**STATE SIGNIFICANT DEVELOPMENT:
Section 96(1A) Modification Application**

AUSTRALIAN TECHNOLOGY PARK, EVELEIGH

SSD 7317 MOD 4

Environmental Assessment Report
Section 96(1A) of the *Environmental Planning
and Assessment Act 1979*

Figure 3: Location of rooftop mechanical exhaust, flue/vent infrastructure and photovoltaics circled red (Source: Applicant's Section 96 application).

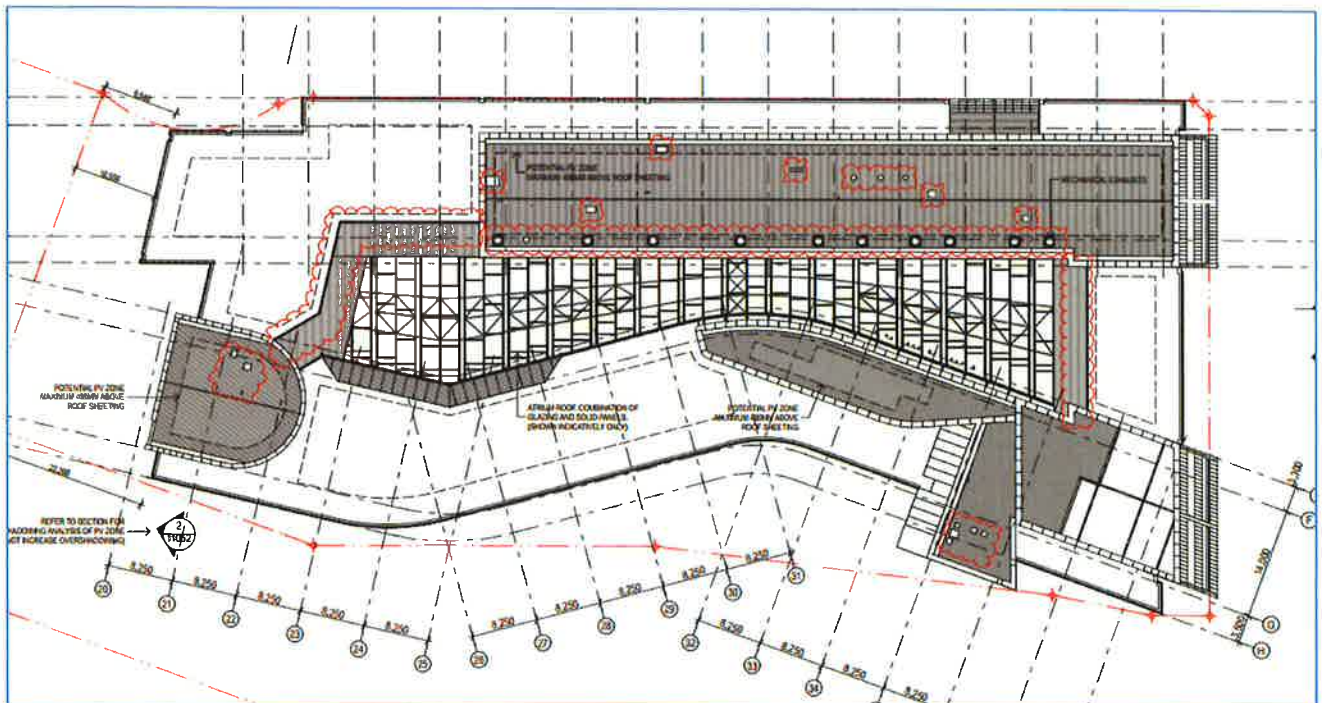
The proposal seeks approval to install mechanical exhausts, flues, vents and photovoltaics, which will protrude between 0.4 and 3 m above the approved roof line. The majority of these will be located on the northern half of the roof and those on the southern half of the roof will be below 1 m in height above the approved roof line (**Figure 3**).

The Applicant states that the flues and photovoltaics have been restricted to the minimum height possible and positioned in plan to ensure their visual impact on the public domain is limited. As each of these elements is positioned away from the roof edge, the acute sightline from street level prevents any of the flues or photovoltaic cells from being seen at street level.

The Department notes the location of the exhausts, flues, vents and photovoltaics is not uniform across the approved roof of the building and are set back from the building edge a minimum of 5 m for the exhausts, flues and vents, and 2 m for the photovoltaics which minimises the visual impact from the public domain. It is likely these elements will be imperceptible when read in the context of the whole building. The Department therefore considers these elements are acceptable in design terms and that the overall design quality of Building 1 will be maintained.

Figure 4: Rooftop mechanical exhaust, flue/vent infrastructure and photovoltaics circled red on southern elevation (Source: Applicant's Section 96 application).

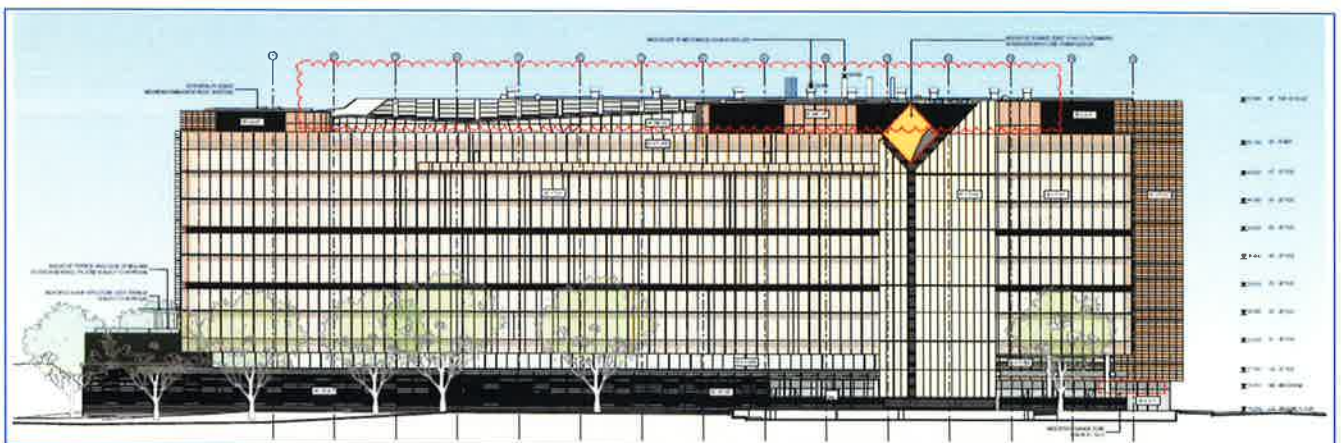
The Applicant notes that during design development it became apparent that to provide safe and effective dispersion to comply with AS-NZS 5601.1 (Gas Installations), the mechanical exhausts, flues and vents would need to be at least 1.565 m and 3 m higher than the roof level of the building respectively. In addition, the photovoltaics need to be positioned approximately 0.4 m above the roof sheeting level.

The modification therefore seeks to increase the overall maximum height of the approved building from 57.9 m AHD to 60.9 m AHD.
